URGENT Field Safety Notice

Philips Allura and Azurion systems
Risk of patient fall from the table associated with the use of the mattress

01-May-2026

Addendum

Figure 1 – Incorrect positioning of the neuro mattress

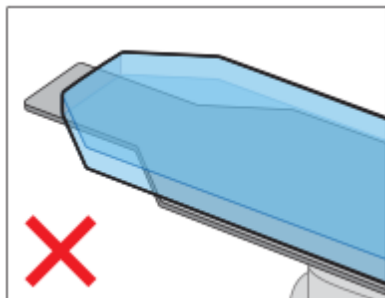
- **Incorrect positioning of the neuro mattress on the table:** If the neuro mattress is positioned at the top of the table, the mattress will cover the neuro table head leaving the mattress unsupported in this area. The patient could fall if while positioning/making comfortable, the patient places their hand on the side of their head, where the mattress is not supported by the tabletop (see figure 1).

- Circulate this URGENT Field Safety Notice letter to all users of the system so that they are aware of the issue.
- Follow the instructions of section “2 Positioning the Patient on the Table” and section “4 Mattress” of the addendum to the Instructions for Use “Patient Table” that was provided with your system. For convenience, we are providing a copy of this addendum together with this letter. This addendum includes information for the transfer of the patient and the correct use and positioning of the mattress.

Figure 2 – Incorrect use of mattress

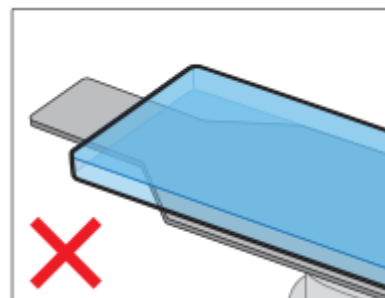
- **Incorrect mattress being used on table:** If a cardiac (long) mattress is used on a neuro table, the mattress will cover the neuro table head leaving the mattress unsupported in this area. The patient could fall if while positioning/making comfortable, the patient places their hand on the side of their head, where the mattress is not supported by the tabletop (see figure 2).

Figure 1 Correct mattress positioning: the entire mattress is supported.

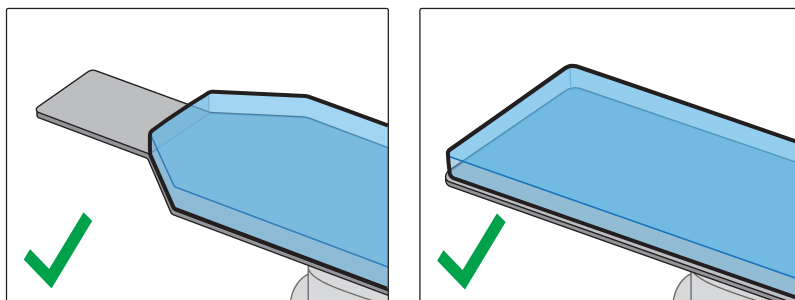
- Use a mattress that is appropriate for the table.
- When positioning the mattress, ensure that the entire mattress is supported by the tabletop.
- Pay particular attention when working with the neuro tabletop and mattress: do not position the mattress on the narrow area of the neuro tabletop.

Figure 3 Example of mattress movement during patient transfer or repositioning which could lead to the patient falling

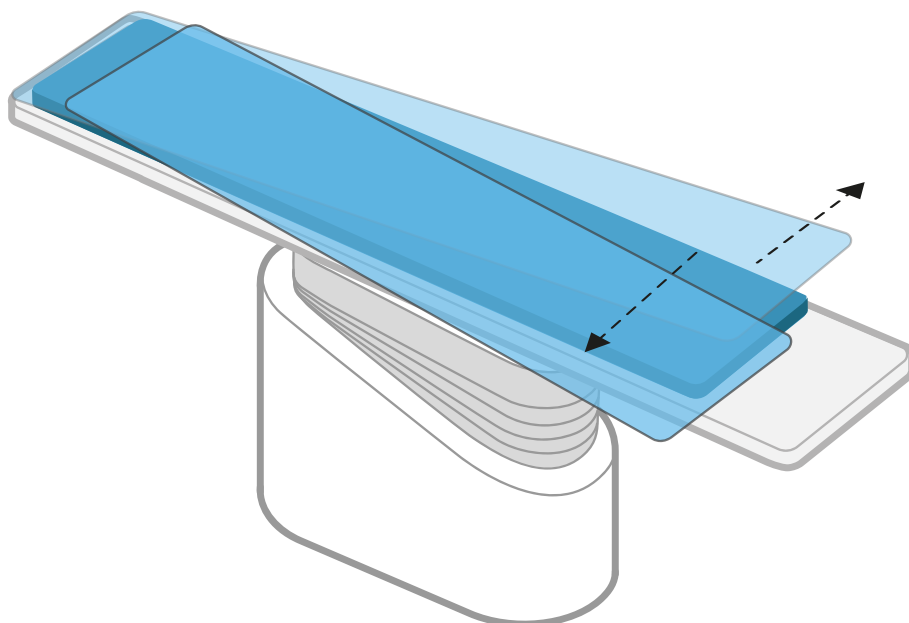
- Communicate clearly with other hospital staff during the transfer process to ensure that everyone is aware of the patient's weight and position.
- Open the air plug of the mattress. Opening the air plug allows the mattress to expand and contract with the weight of the patient.
- Ensure that patient transfer devices are used correctly.
- Move the patient carefully and avoid movements that could cause the mattress to slip.
- If a patient positions themselves on the table, ensure that the patient knows that the mattress is not fixed to the table.

Figure 4 Table float (longitudinal) movement finger entrapment risk areas

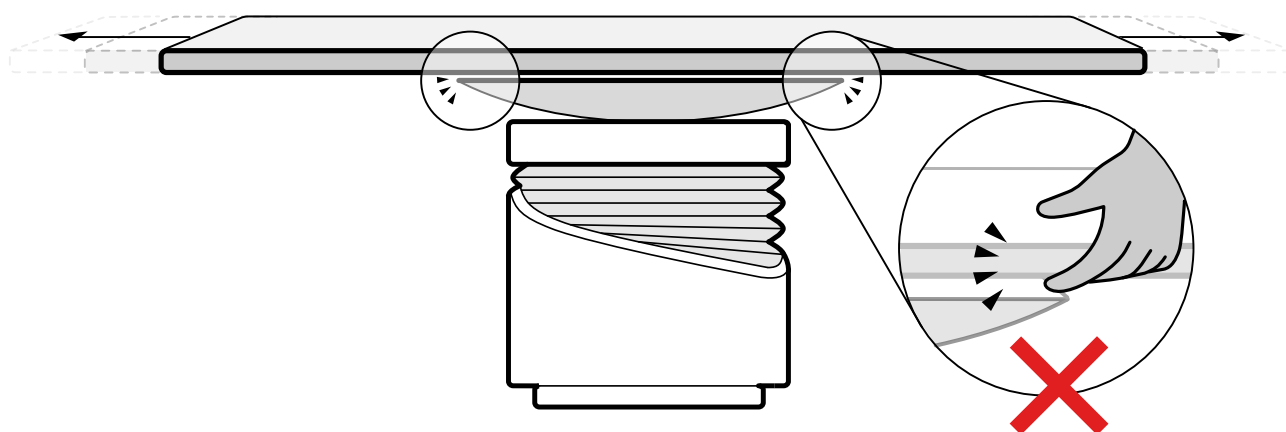
Beware of finger entrapment. Do not place your fingers beneath the tabletop when floating the tabletop.

Figure 5 Table tilt movement finger entrapment risk areas

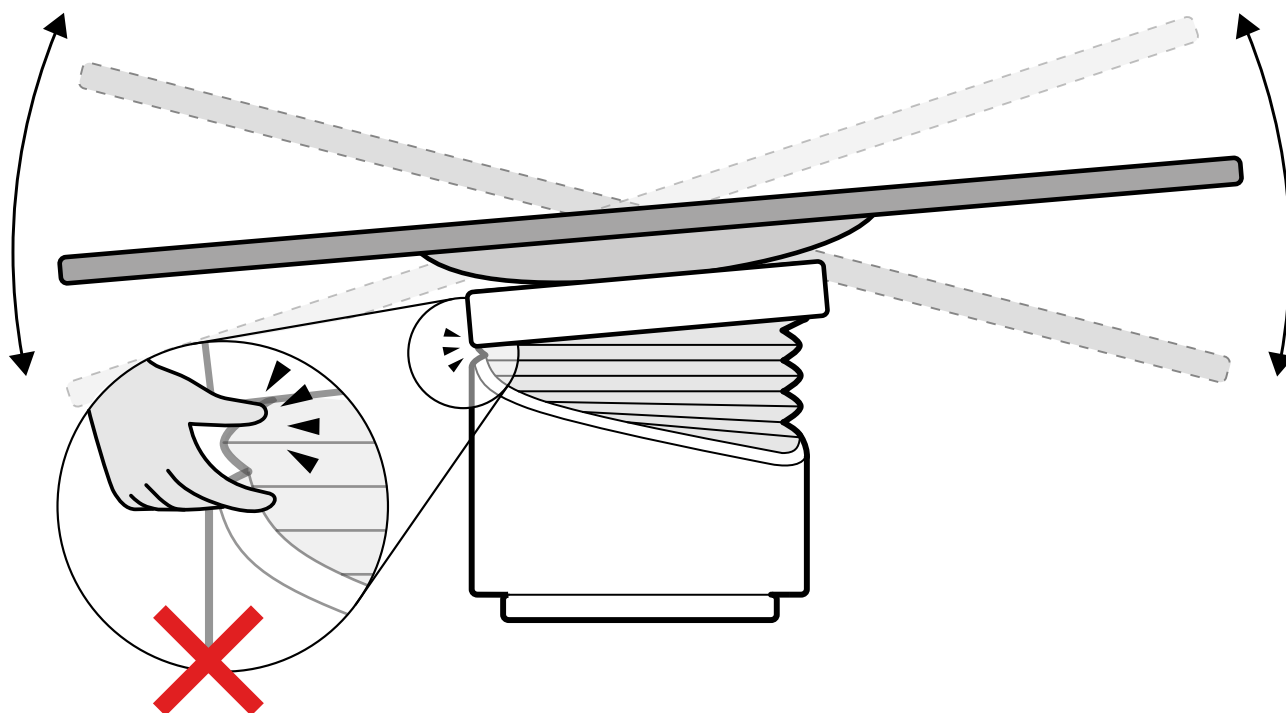
Beware of finger entrapment. Do not place your fingers on the table bellows during tilting.

Figure 6 Table cradle movement finger entrapment risk areas

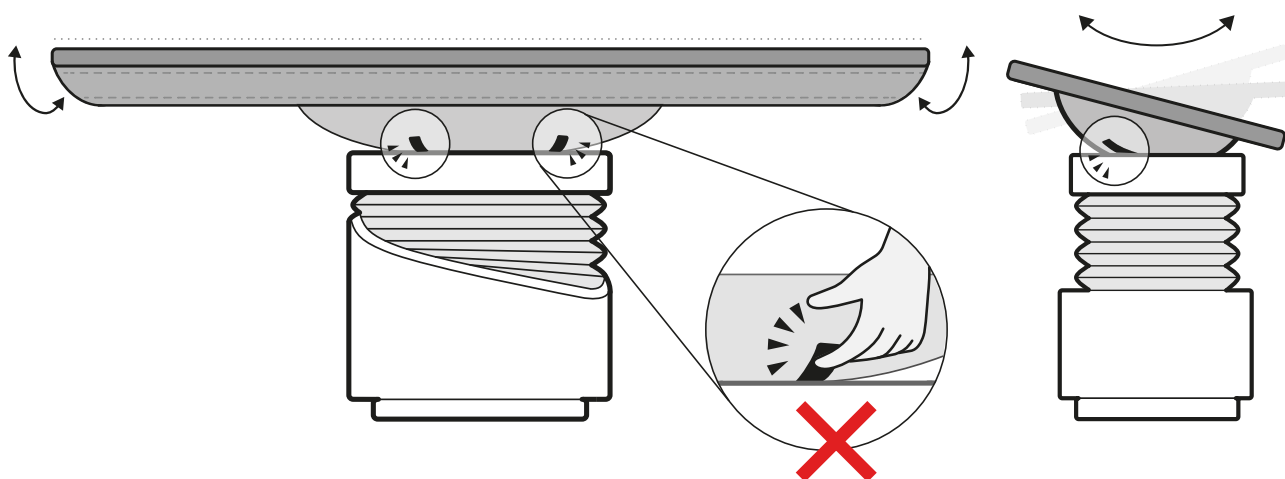
Beware of finger entrapment. Do not place your fingers where the tabletop meets the table base when cradling the tabletop. Depending on your patient table configuration, there may be more than one opening below the tabletop.
